Service Bulletin

S.B. No: 161

Title: FUEL TANK VENT PIPE CHECK

Applicability: T67C Post Mod M156, T67M-MkII, T67M200, T67M260 and T67M260-T3A

Figure1 Wing Tank Fuel Vent Pipe

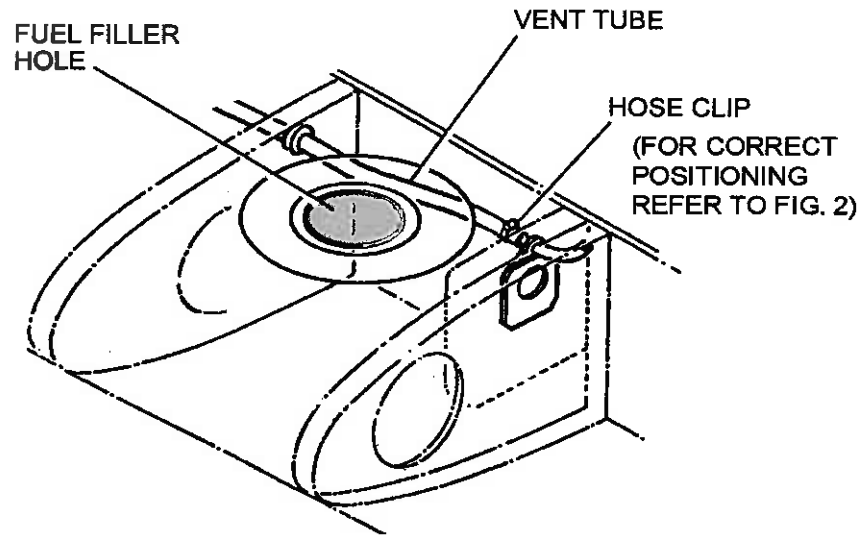
1. Remove fuel filler caps from both wing tanks, ensure safety precautions are observed.
2. Using a mirror and a torch (if required) observe fuel vent tube, ref Figure 1.
3. Check:
 - i) Correct routing of vent tube, ie straightness. If tube is slack ensure it cannot be fouled by refuelling nozzle.
 - ii) Vent tube hose clip is still in its correct position, tight and is correctly supporting the vent tube. Ref Figure 2a (Pre Mod M554) or Figure 2b (Post Mod M554).
4.
 - i) Should inspection prove satisfactory annotate logbook "SB161 complied with."
 - ii) If requirements of paragraphs 3 i) and ii) cannot be satisfied then gain access to wing tank as per Maintenance Manual and rectify. Upon rectification annotate logbook "SB161 complied with."

Figure 2a PRE MOD M500/M554

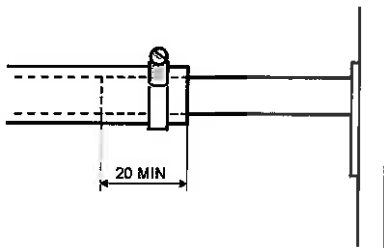
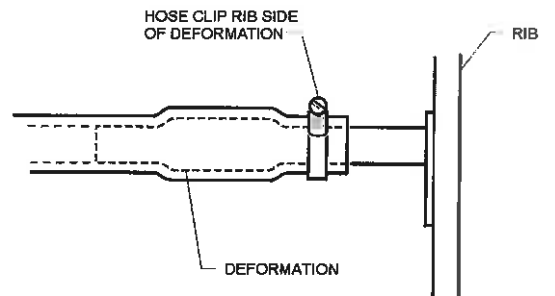
Note if upon rectification, tube had to be pulled onto fittings to obtain correct position, then it is recommended that the root vent fitting is also checked to ensure that the dimensions on Figures 2a or 2b are met. If it is not possible to achieve the dimensions, then replace vent pipe (SAL Stores Code No. 126-36-054) ensuring vent line is installed as straight as possible.
